# MONITORING YEAR 3 ANNUAL REPORT

## HENRY FORK MITIGATION SITE

Catawba County, NC  
DEQ Contract No. 005782  
DMS Project No. 96306

RE: **Response to MY3 Draft Report Comments  
Henry Fork Mitigation Project**  
DMS Project # 96306  
Contract Number 005782  
RFP Number 16-005298  
Catawba River Basin – CU# 03050103 Expanded Service Area  
Catawba County, North Carolina

View Downstream

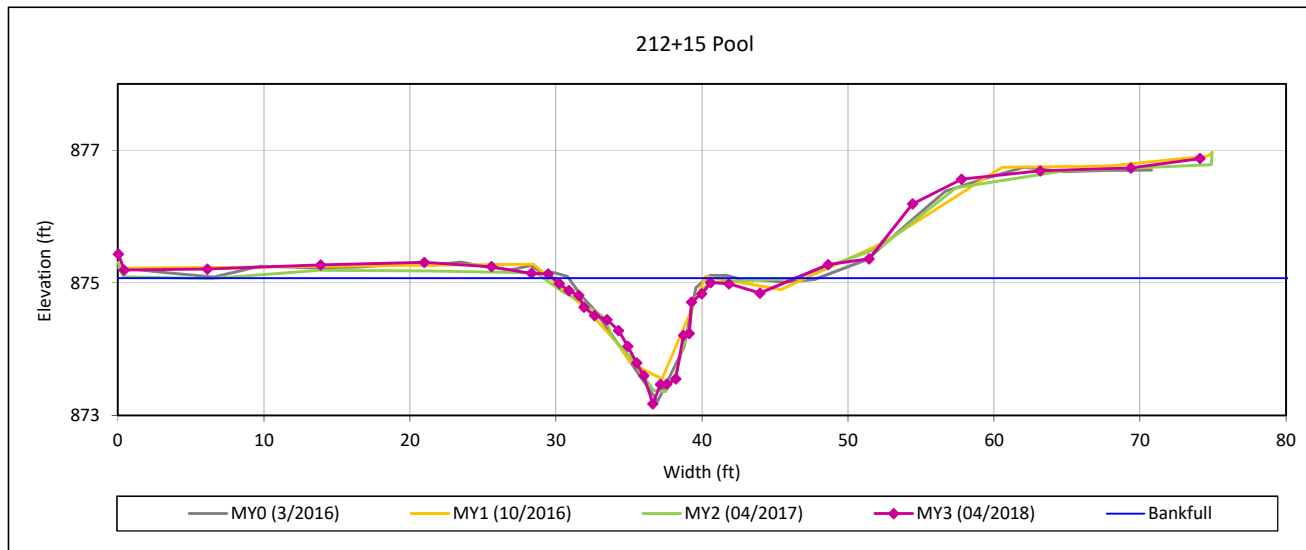
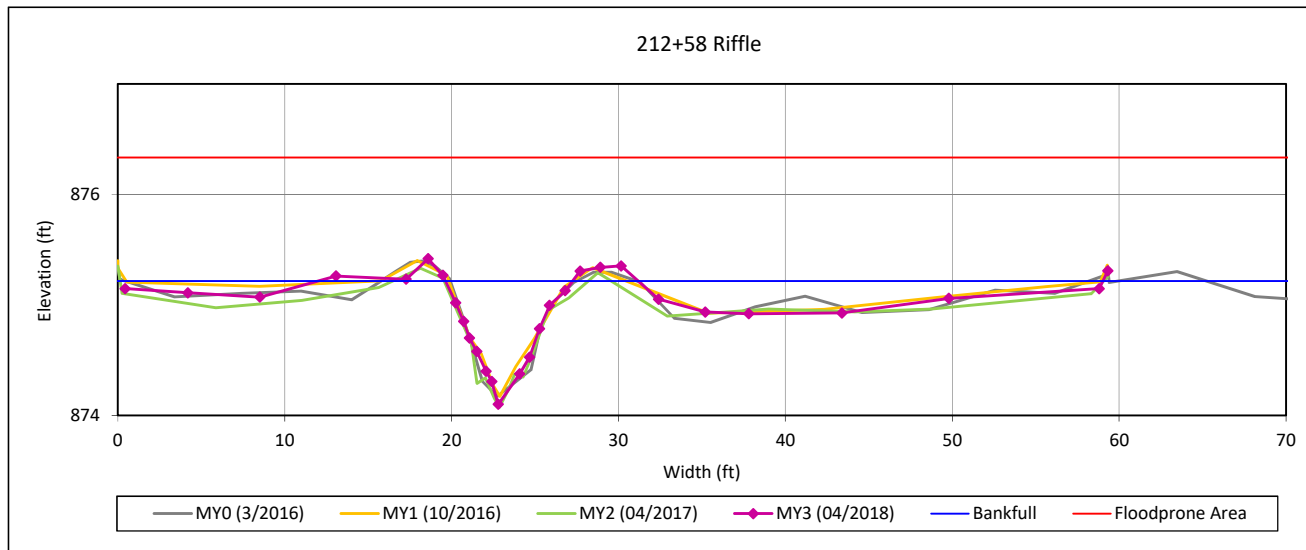
**DMS comment; Cross-sections: Please turn off marker for all monitoring years except MY3 to make graph more legible to reviewers.**

*Wildlands response; Wildlands has updated the cross-sections to remove markers for monitoring years prior to MY3.*

### Groundwater Gage Plots

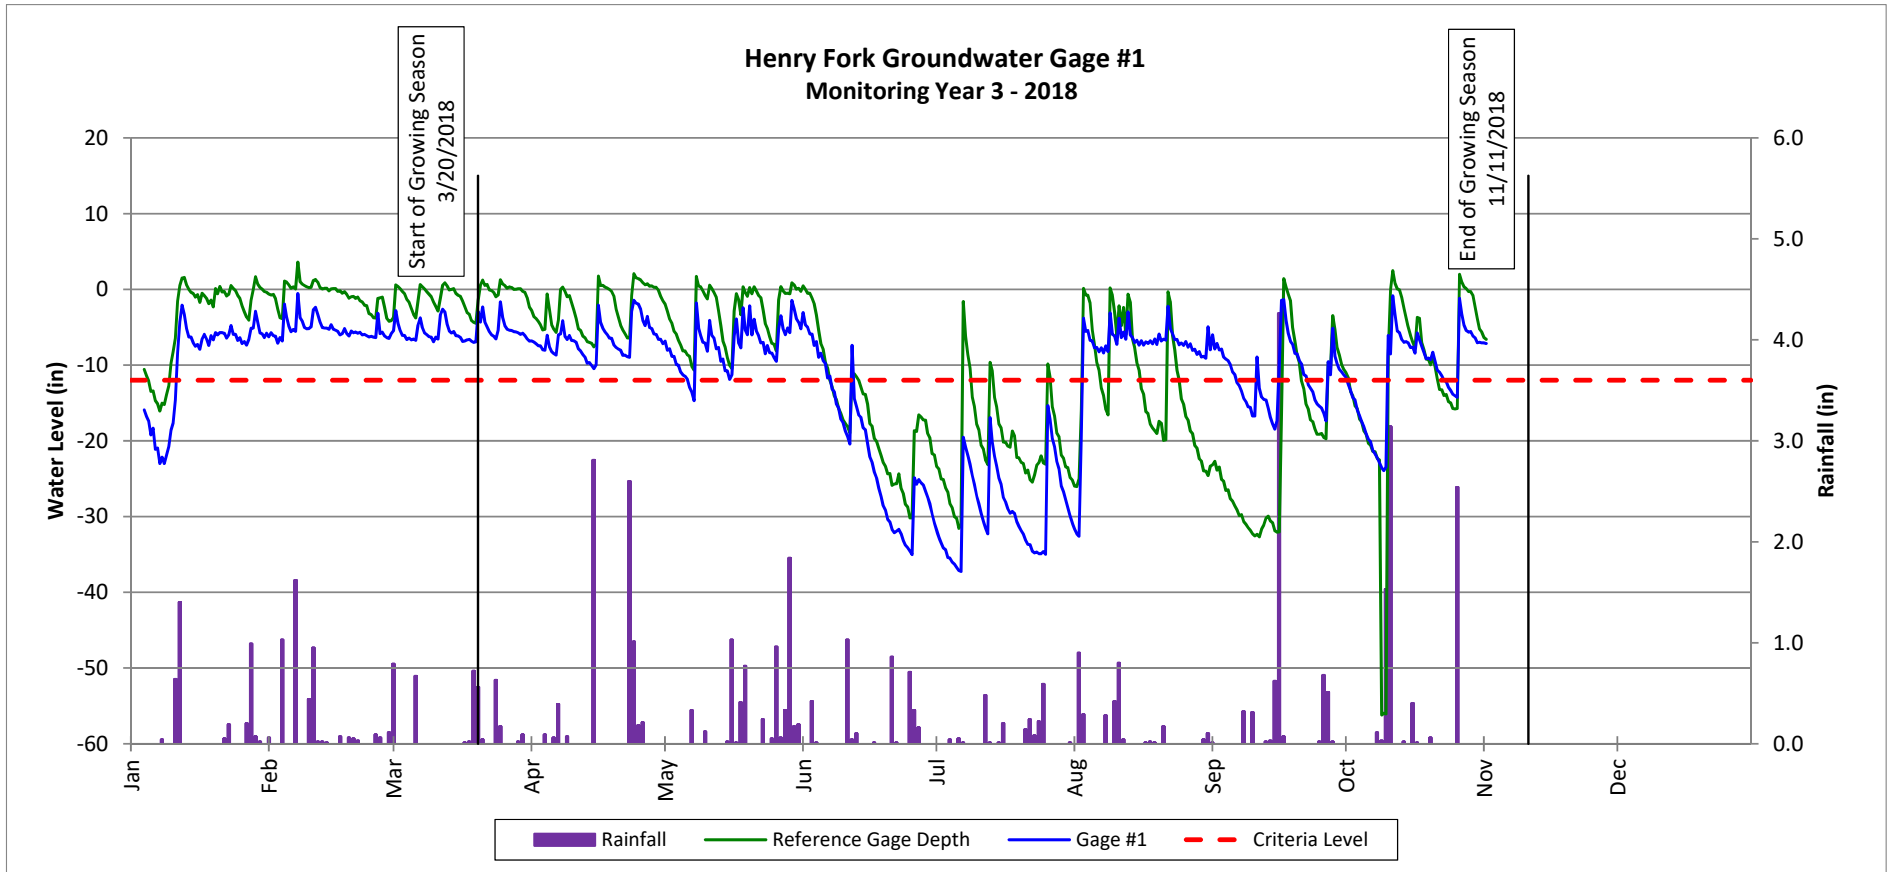
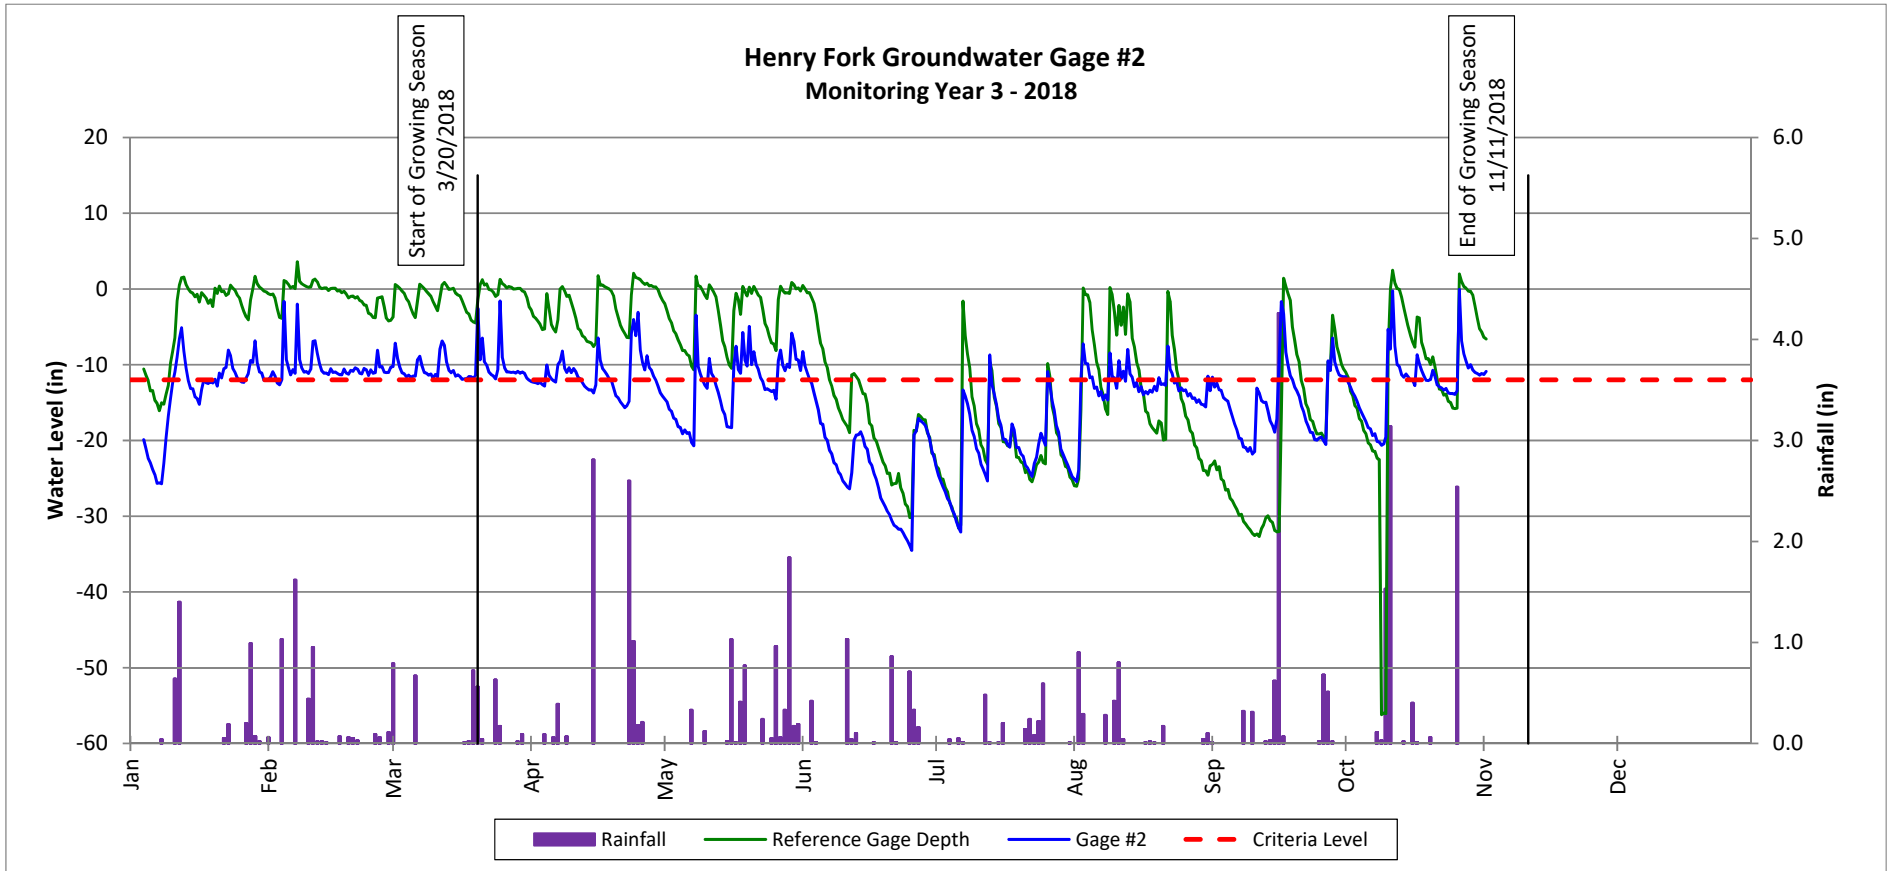
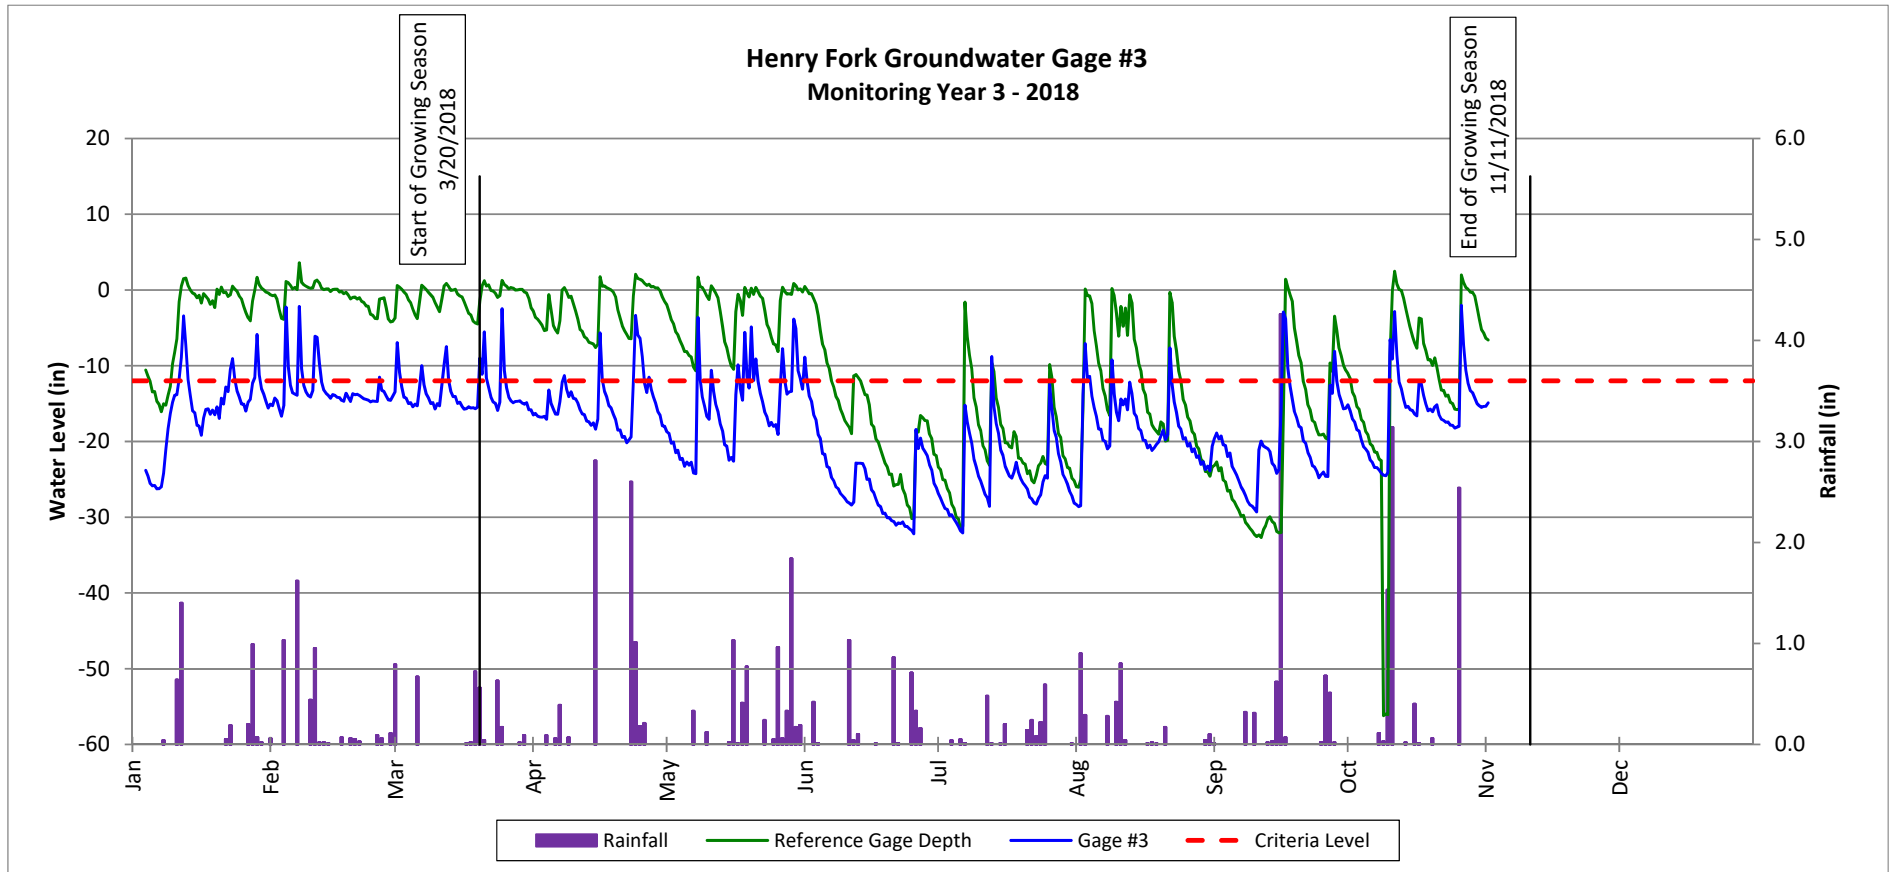
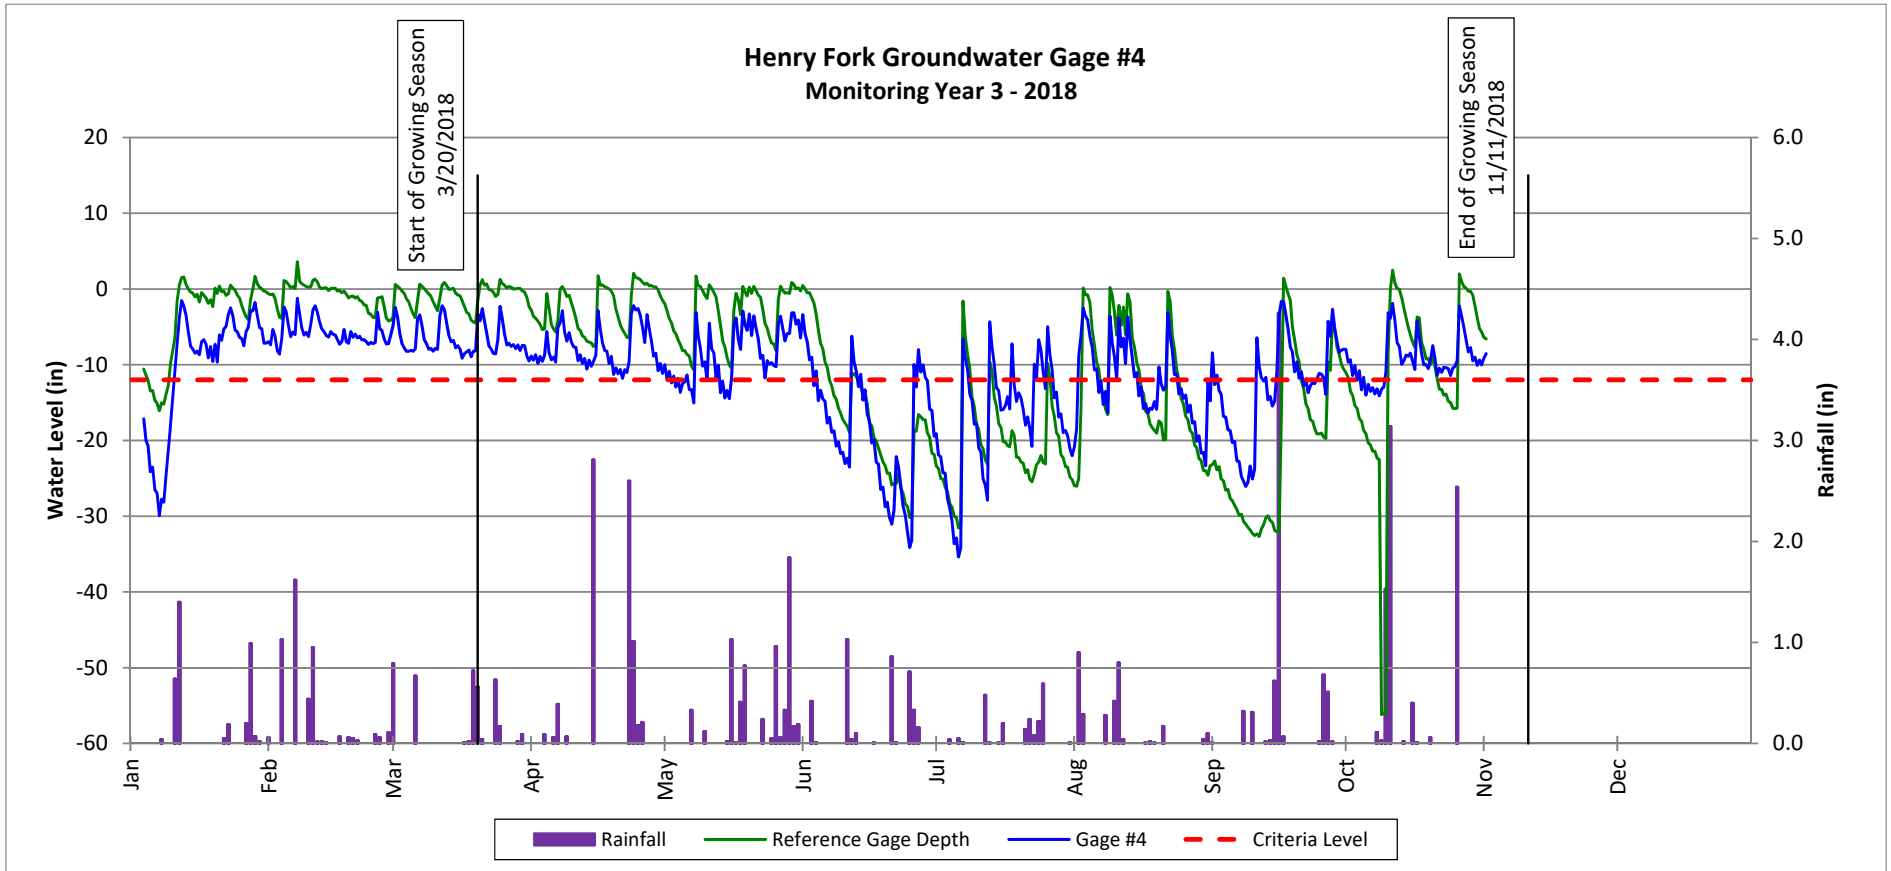
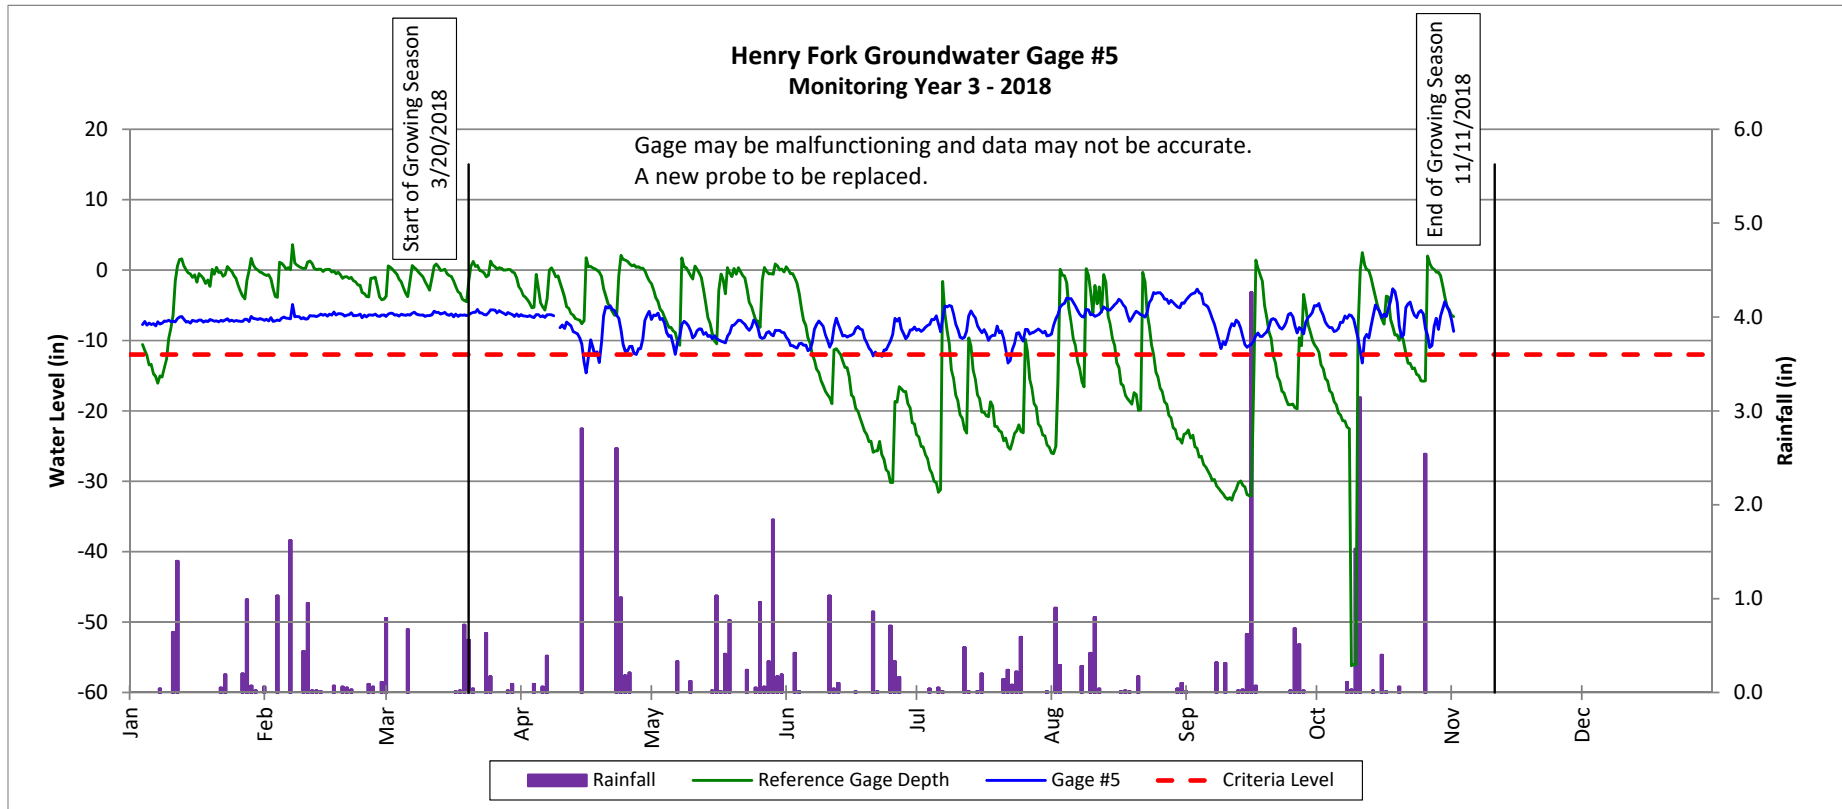
**DMS comment; Groundwater Gage 5 Plot: The report indicates that Wildlands believes Gage 5 may be malfunctioning. Please add a note to graph acknowledging that the data may be inaccurate, and the gage will be replaced.**

*Wildlands response; Wildlands has updated the groundwater gage 5 plot by adding a notation that the probe may be malfunctioning along with the probability that the data may be inaccurate and will be replaced.*
